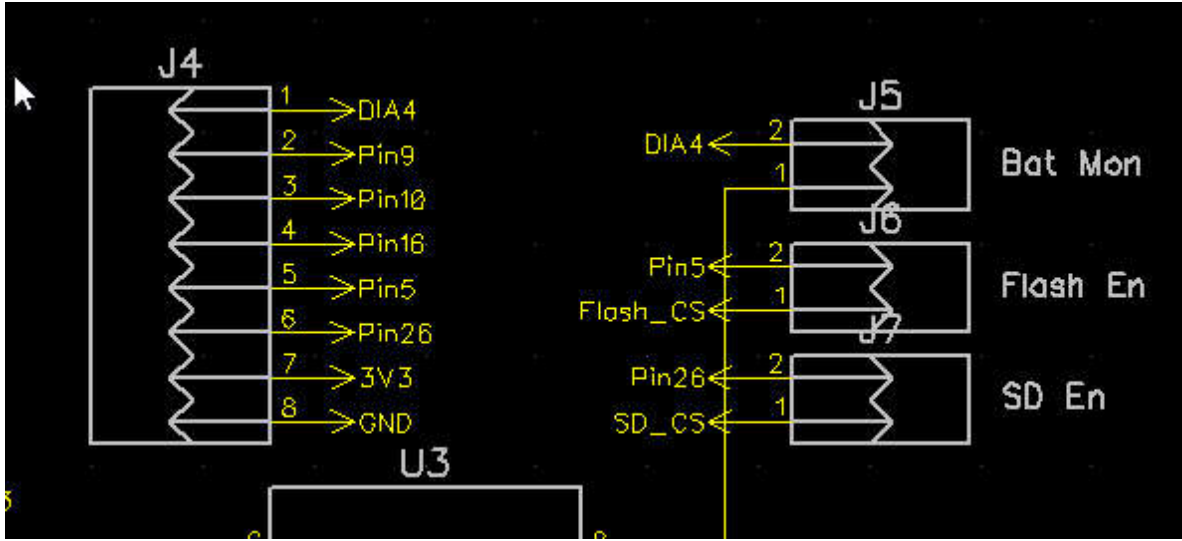
The Silk screen is not correct for some of the pinouts for J4 also the option jumpers. The schematic is correct and should be used instead as a guide.

Battery Monitor voltage divider

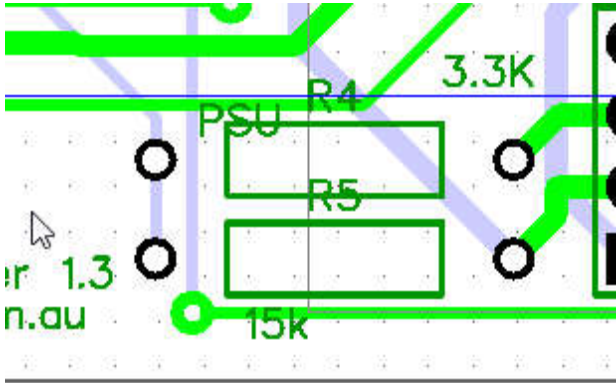
The values of R4 and R5 are transposed on the Silk Screen, R4 should be the high value resistor

Reset Pull Up of 10K is normally provided by the ESP8266 module however when it is not being used the Reset pullup is missing. If you are not using the ESP8266 or the 74HC595 you can add a pull up as shown. Alternatively if you are using the 74HC595 you can add between 6 & 8 on the ESP8266 pad.
